re: Geotechnical Review
Proposed Parking Garage Access Ramp
56 Steacie Drive - Ottawa
to: Merkburn Holdings Ltd - Mr. Peter Dooher - pdooher@merkburn.com
date: June 12, 2019
file: PG4484-MEMO.02

Further to your request and authorization, Paterson Group (Paterson) has completed a review of the proposed ramp detail for the aforementioned site.

- ☐ Project No. 18M-01672-00 - Drawing No. C-02 - Servicing Plan - Revision 2 dated April 3, 2019

1 SERVICING PLAN
C-02 SCALE= 1:250

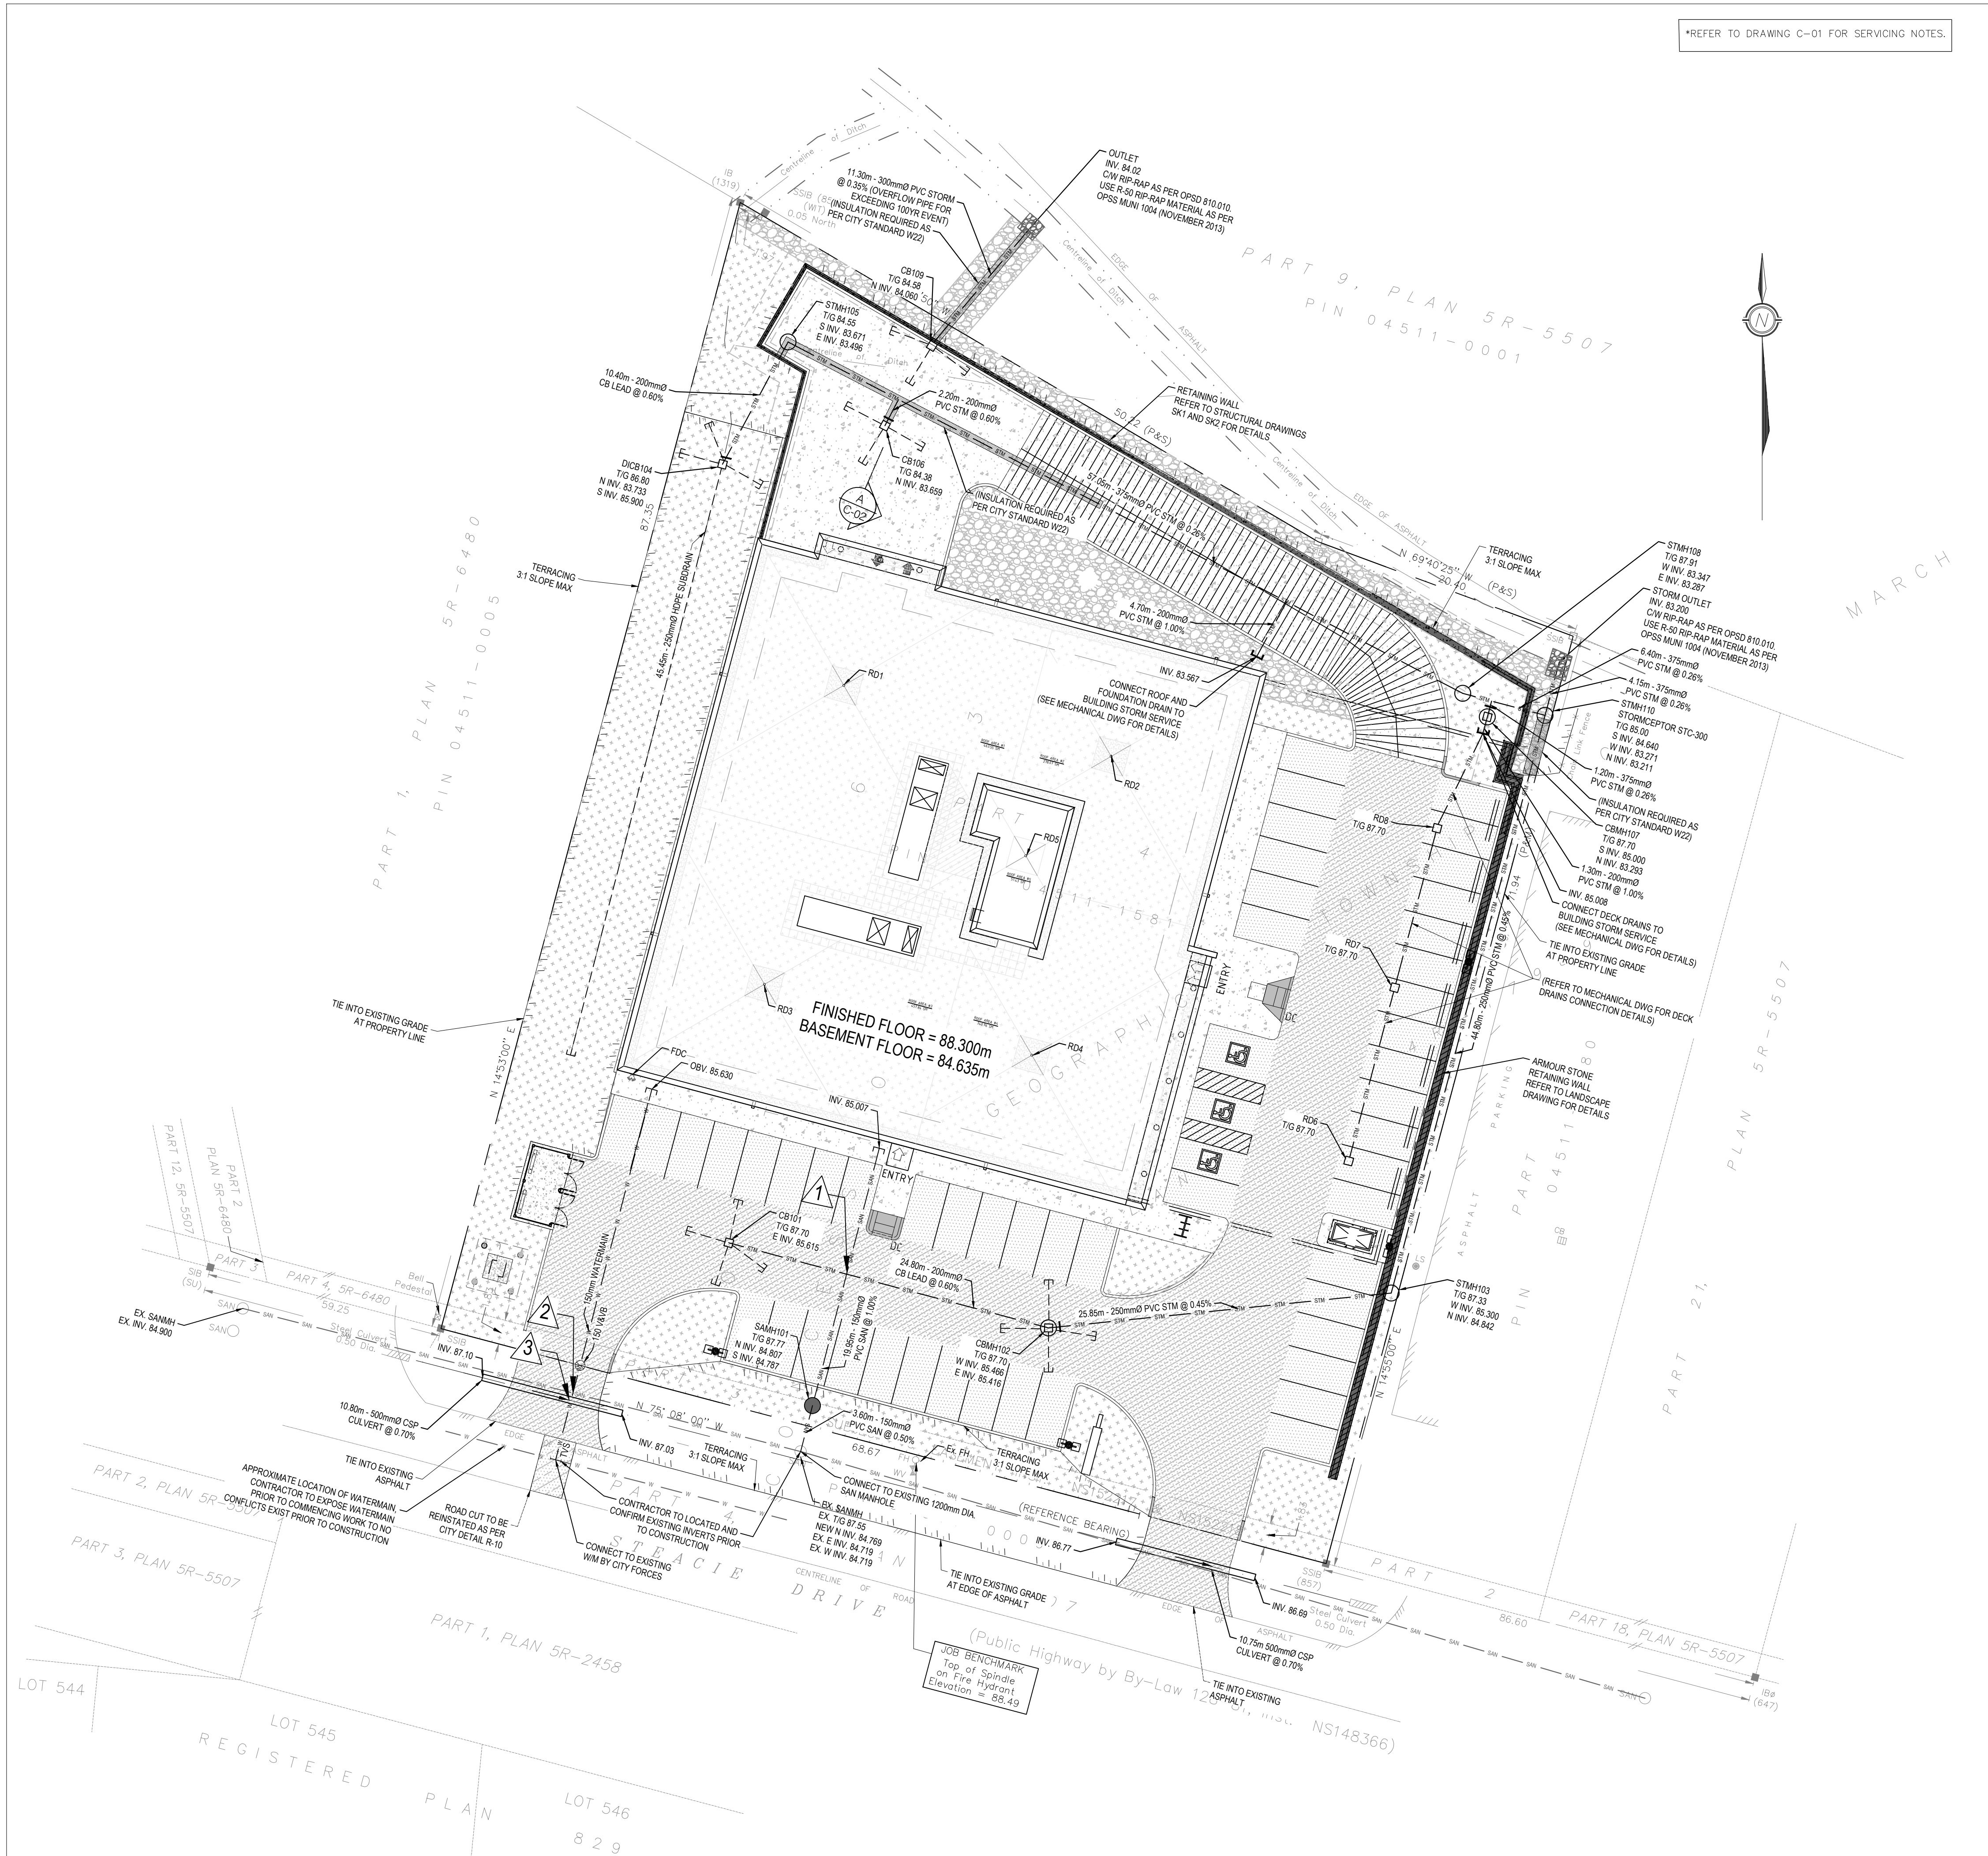
Section A on the above noted drawing shows a cross-section detail at a catch basin with an outlet to the proposed 375 mm diameter storm sewer. Based on the Section A detail, the total available frost cover above the outlet pipe is 521 mm, including the proposed 200 mm thick concrete pavement. In order to ensure adequate frost protection, it is understood that heat tracing will be provided within the concrete slab. It is further understood that the proposed outlet pipe will be wrapped with insulation resulting in a reduction of the granular material thickness for the pavement structure to approximately 270 mm below the concrete slab.

Based on our review of the above noted detail, the localized reduction in pavement structure granular thickness is considered acceptable from a geotechnical perspective.
